Key DIRECTV Comments

Thin Client Base Allowance

ENERGY STAR STB Data Analysis - CBL+SAT+IP

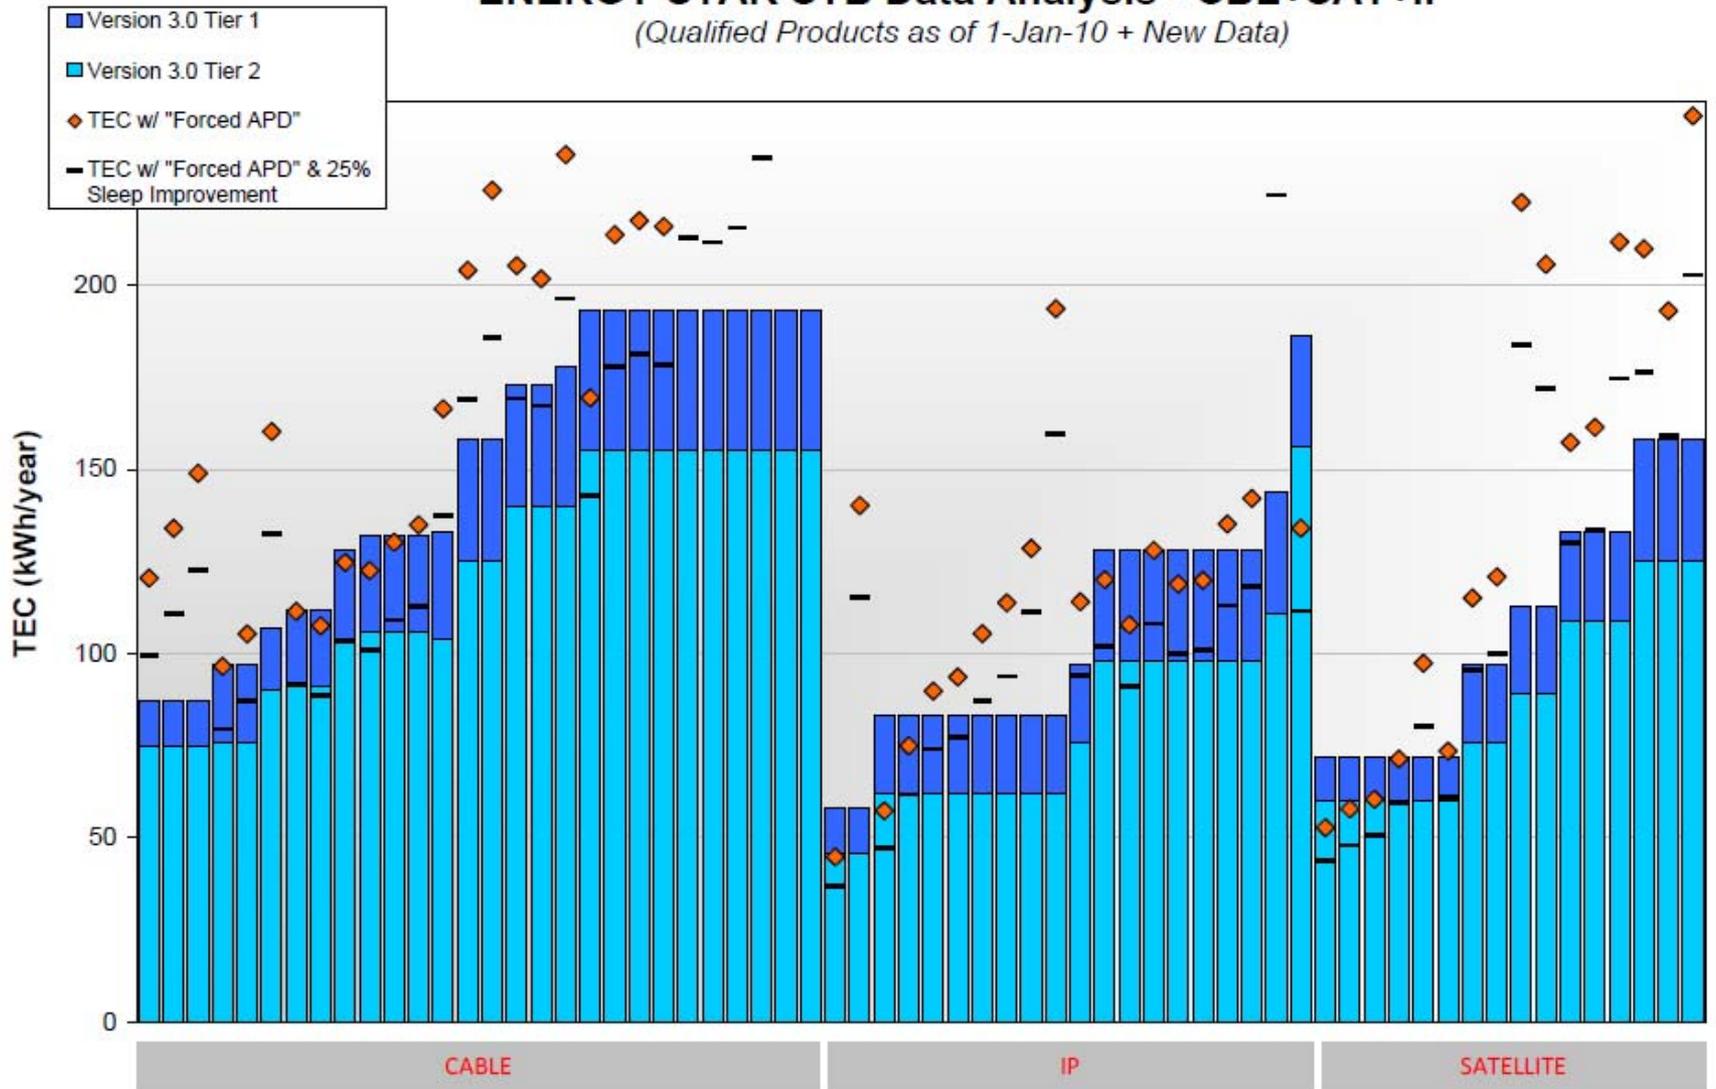
- The EPA explains in its cover letter of February 23 that it “aligned the base allowance for Satellite STBs with the base allowance for Cable STBs”.
- By setting the base allowance for Satellite STBs to be the same as for Cable STBs, however, it effectively eliminated from Satellite STBs any allowance for the smart card based conditional access used by satellite service operators.
- EPA’s chart that follows pictorially demonstrates a difference of ~35 kWh/year between Cable STBs and Satellite STBs
 - DOCSIS annual energy allowance of 20 kWh/year is not applicable to Satellite, as this is cable-specific functionality that allows 2-way communications with cable head-ends
 - CableCard annual energy allowance of 15 kWh/year is applicable to Satellite, however, as Satellite STBs universally require conditional access as well

- In the same way that the CableCard based conditional access used by cable operators was not removed from the Version 3.0 Tier 1 specification, an allowance must remain in place for the smart card based conditional access used by satellite service operators.
- A simple way to address this inequity would be for the additional functionality currently called “CableCard” to be renamed “Replaceable Conditional Access” and be applicable for both Cable STBs and Satellite STBs.
- In this way the allowances for Satellite STBs and Cable STBs would truly be aligned, as was the EPA’s intention.
